8-A-21-HZ
APPLICATION FOR CERTIFICATE OF APPROPRIATENESS

1404 Kenyon St. 37917
Old North Knoxville H

Original Print Date: 8/9/2021
 Knoxville/Knox County Planning -- Historic Zoning Commission

Fig. C, D, and E: 1404 Kenyon upon removal of vinyl siding from front (left) and rear (right), and southwest corner.

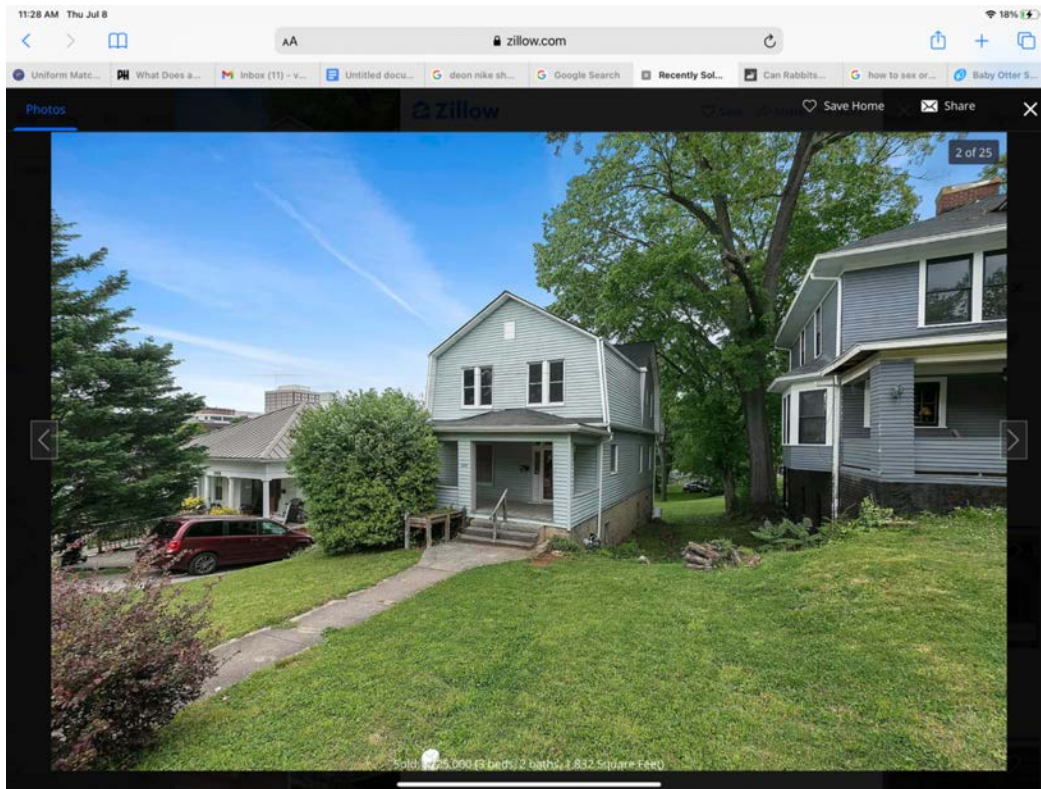
3. An archival photo from 1992 shows the façade's second story clad in wood shingle siding. Dating to 1992, the NR nomination also lists the weatherboard and wooden shingle wall covering" as character-defining feature of the house.

6. Guidelines recommend that replacement siding "must duplicate the original," including trim or patterned shingles. Guidelines also note that entire wooden features that are completely missing shall be replaced in-kind, with materials that are compatible with the original in size, scale, and material. Replacement elements should be based on historical, pictorial, and physical documentation. Existing conditions on the house show visible ghost marks (namely, small vertical lines) where the original shingle siding was located on all second-story gable fields.
-

Staff recommends approval of the installation of new siding, with the front, side, and rear gable fields to receive wood shingles to reflect the original siding pattern; providing for discussion between the Commission, applicant, and neighborhood on the second-story sections outside of the gable fields.
